Access Compliance Report

Public Rights-of-Way

Intersection ID: 44317	Main Street: E_9TH_ST	Cross Street: N_CALDWELL_ST	Location: S
ADA ID: AC7E4BC4B5AD	Ramp Type: PerpDiag	Initial Pass/Fail: Fail	Overall Compliance: No
Severity Score: 13.75			
Codes/Mitigation Info/Possible Solution		Field Measurements/Component Compliance

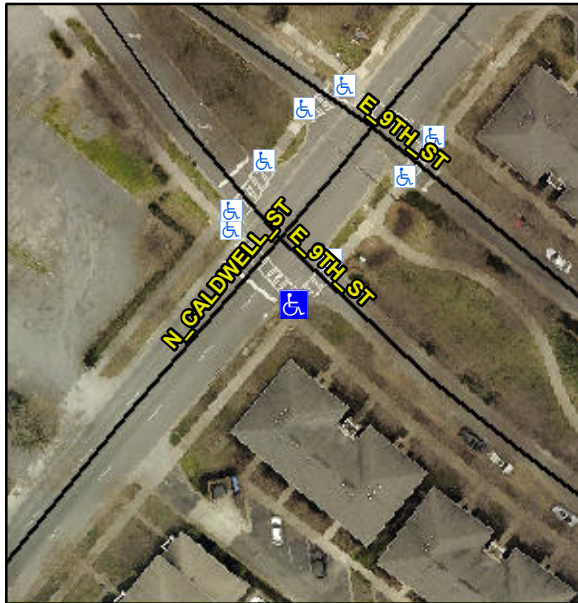
Not Found, R304.2.2, R304.5.3

Compliance	Description	Data	Compliance	Description	Data
N/A	Ramp Length (in)	58.0	No	Ramp Slope (%)	9.0
Yes	Ramp Width (in)	50.0	No	Ramp XSlope (%)	4.7
N/A	Flare Type LT	N/A	N/A	Flare Type RT	N/A
N/A	Flare Slope LT (%)	N/A	N/A	Flare Slope RT (%)	N/A
N/A	Flare Traversable LT?	N/A	N/A	Flare Traversable RT?	N/A
N/A	Landing Length (in)	N/A	N/A	DWS Provided?	N/A
N/A	Landing Width (in)	N/A	N/A	DWS Contrast?	N/A
N/A	Landing Slope (%)	N/A	N/A	DWS Length (in)	N/A
N/A	Landing X Slope (%)	N/A	N/A	DWS Full Width?	N/A
N/A	Landing Curb? (Y/N)	N/A	N/A	DWS Offset (in)	N/A
N/A	Shared Landing?	N/A			
N/A	Gutter Ponding?	N/A	N/A	Gutter Slope (%)	N/A
N/A	Gutter Lip Ht (in)	N/A	N/A	Gutter X Slope (%)	N/A
N/A	Painted X Walk1?	Yes	N/A	Painted X Walk2?	Yes
	X Walk 1 Direction	To NE		X Walk 2 Direction	To NW
N/A	X Walk 1 Width (in)	101.0	N/A	X Walk 2 Width (in)	100.5
	X Walk 1 Slope (%)	3.3		X Walk 2 Slope (%)	3.6
	X Walk 1 X Slope (%)	3.9		X Walk 2 X Slope (%)	2.4

Remove & Replace Curb Ramp With Two New Directional Ramps or Equivalent.
